HICUM - User Support Update

Q&A Section - Level2/v2.1

... from Dave Sheridan's recent feedback summary

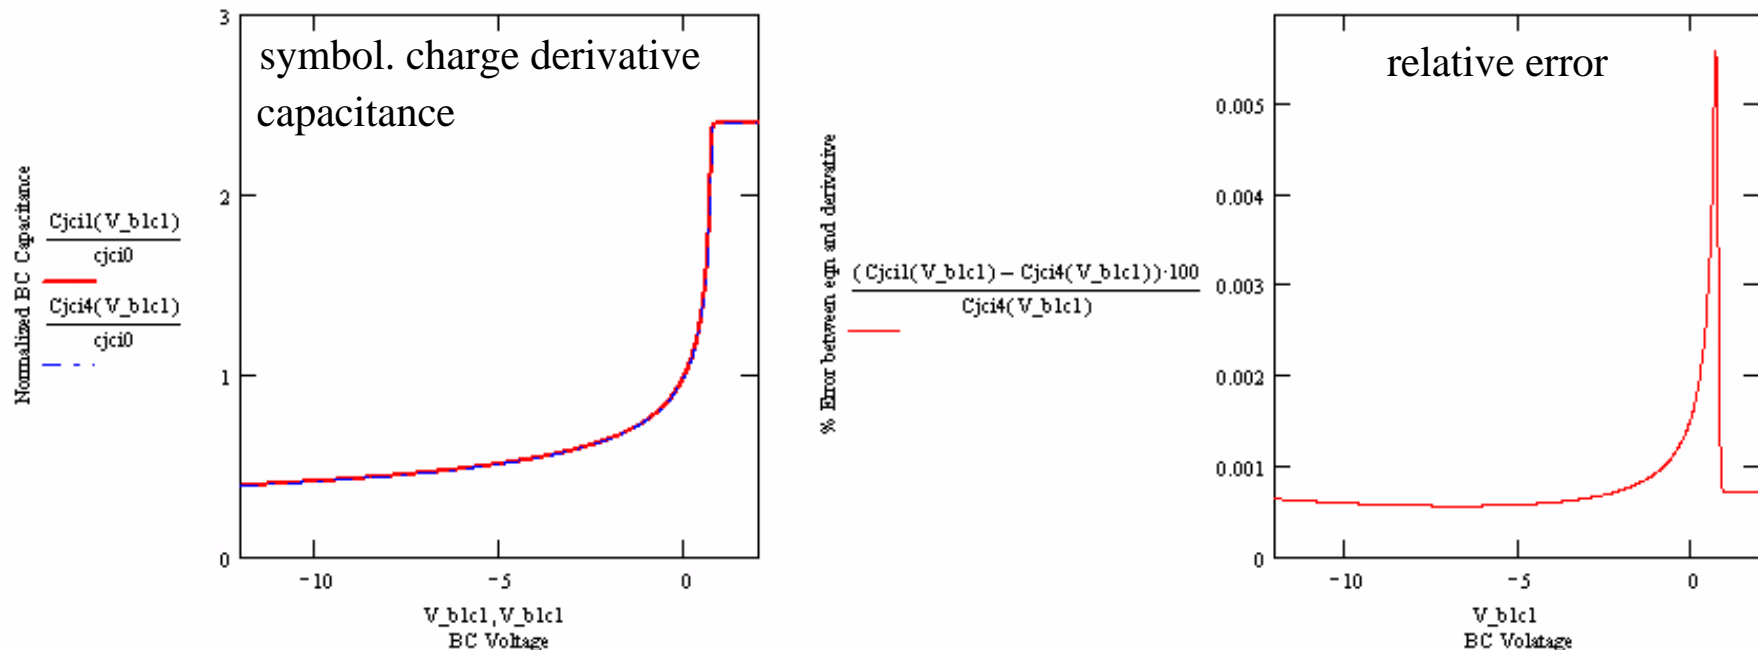
- Q6: V2.1 Fortran version does not contain complete derivatives and no Verilog-A V2.1 is available for checking/implementation.
- A6:
 - Verilog v2.1 code is available to replace FTN code
- Q7: The documentation indicates full self heating (2.1.16-1), but the Fortran code does not.
- A7:
 - investigations have shown that evaluating the other terms adds CPU time but no significant accuracy improvement, especially compared to the uncertainty in RTH, CTH values
 - => left out (corresponds to good approximation of heat term) in v2.1.a
 - for commercial applications full derivatives may be desired

Solution: Verilog V2.1.b with all terms
